COLORADO GEOLOGICAL SURVEY

October 23, 2023

Subject: **Minturn North Final Plan for Planned Unit Development**
Town of Minturn, Eagle County, CO; CGS Unique No. EA-21-0008

Figure 1: Alluvial/Debris fan and mapped landslides within/adjacent to the project site.

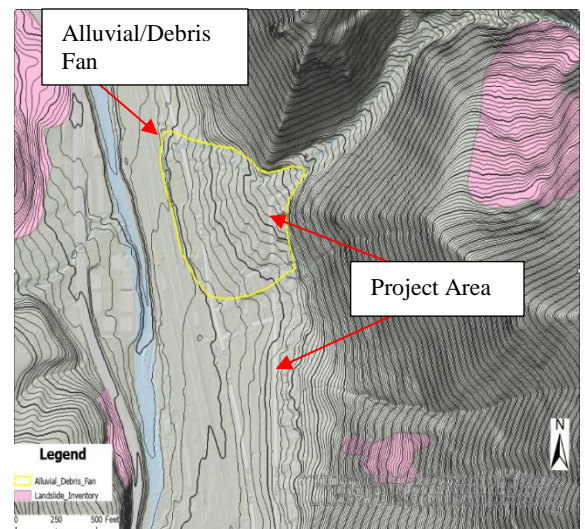
As shown in Figure 1 and as referenced in WWE's drainage study and CTL's and Kumar's reports, an alluvial/debris fan is located at the mouth of Game Creek, which could be a source of debris inundation during a flood event. It should also be noted that existing residential structures are located within/adjacent to the mouth of Game Creek and within the alluvial/debris fan. WWE's cursory mudflow evaluation states, "While the geologic mapping and existing topography indicate that the development site has historically seen active mudflows, there is no evidence of recent mudflow events in the area." However, a detailed mudflow/debris flow analysis for Game Creek was not included in their scope.

As indicated by CTL (page 5) in their report and WWE (page 18) in the drainage report, "Evaluations with regard to mud and debris flows should be completed and evaluated with regard to the proposed development." To the best of our knowledge, this evaluation(s) has not been conducted during our current and previous reviews of this development. Based on the grading plans (sheets C.6 and C.7), a 2.5-foot high deflection berm is planned between Game Creek and Lots 1-5, and a trapezoidal ditch (24 inches deep) is proposed along the east side of the development. However, CGS has yet to receive the mudflow/debris flow analysis for which this deflection berm was designed. Without this analysis, whether the proposed berm will deflect/convey flows (hypercontracted flooding, mudflows, or debris flows) emanating from Game Creek is unknown. WWE states in their cursory review, "This berm will help to reduce the risk of a mudflow from Game Creek impacting the development from the north," but also states, "mudflow events could spill out of Game Creek and impact Taylor Street and the PUD from the west." CGS is

concerned that the risk of debris flows/mudflows has not been assessed and that the berm does not eliminate the mudflow and debris flow hazards on the site and could exacerbate the risk to the existing development.

CGS continues to agree with CTL and WWE and recommends the risk of flood hazards, mudflows, and debris inundation emanating from Game Creek to the alluvial/debris fan is evaluated for both the proposed and existing developments prior to approval. CGS recommends expanding the existing drainage/hydraulic studies or a new study to analyze bulked flow dynamics associated with hyperconcentrated flooding emanating from Game Creek for 10-, 25- and 100-year storm events. In addition, we recommend the following:

- Characterization of the source area and channel areas above the alluvial/debris fan.
- Test pits or trenches to evaluate details on past deposition. Radiocarbon dating of debris flow deposits within the alluvial/debris fan can be used to estimate the age of events and reoccurrence interval.
- A discussion of the anticipated probability of reoccurrence and volume and estimation of flow type, flow depth, deposition area, runout, gradation of debris, flow impact forces, streamflow inundation, and sediment burial depths.
